FILE P.I. #762606-
STP00-7626-00(060)
Fulton County
SR 9/Roswell Road. From Meadowbrook
Drive to Long Island Drive

SUBJECT APPROVED REVISED CONCEPT REPORT

REVISED PROJECT CONCEPT REPORT

Project Number: STP-7626-00(060)

| <p>THE LPA GROUP INCORPORATED TRANSPORTATION CONSULTANTS 3595 ENGINEERING DRIVE NORCROSS, GEORGIA 30092 (770) 263-9118</p> | <p>STATE OF GEORGIA DEPARTMENT OF TRANSPORTATION</p> | <p>TYPICAL SECTION ROSWELL ROAD SIDEWALKS - PHASE I CITY OF SANDY SPRINGS P. I. NUMBER 762606</p> |

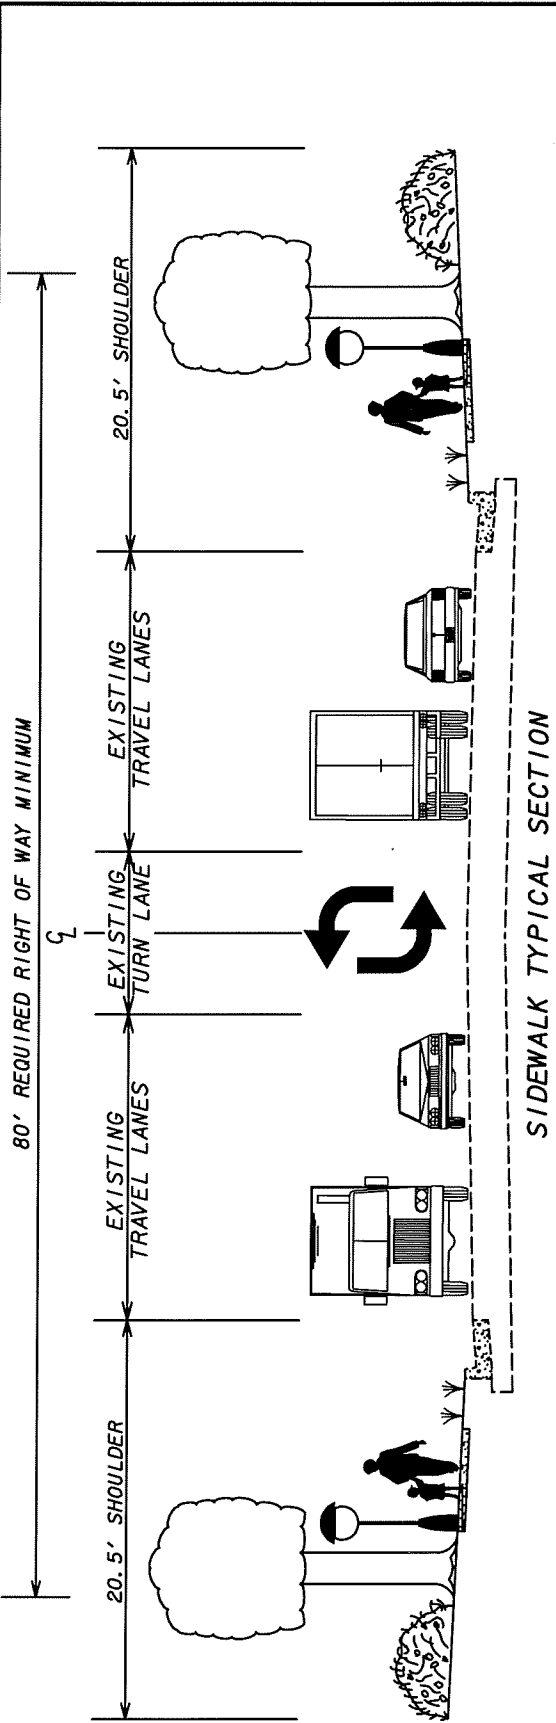
- The typical section will be revised to show clarification of the size and placement of the sidewalk lights and the pedestrian clear zone within the sidewalk area.
